Access Compliance Report

Public Rights-of-Way

Intersection ID: 53380	Main Street: IKEA_BV	Cross Street: LEWIS_ST	Location: S
ADA ID: 36FBF3C8874F	Ramp Type: Directional1	Initial Pass/Fail: Pass	Overall Compliance: No
Codes/Mitigation Info/Possible Solution		Field Measurements/Component Compliance	
Severity Score: 7.5

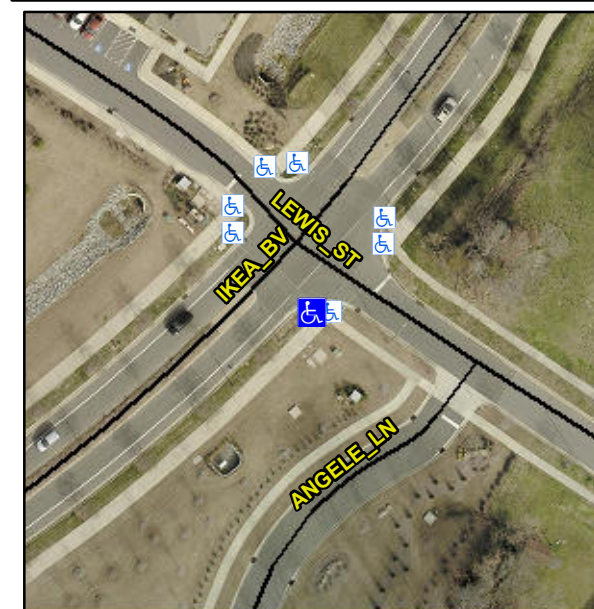
**Remove & Replace Entire Ramp.
Remove & Replace Gutter.**

R304.5.2, R302.7.2, R304.5.3
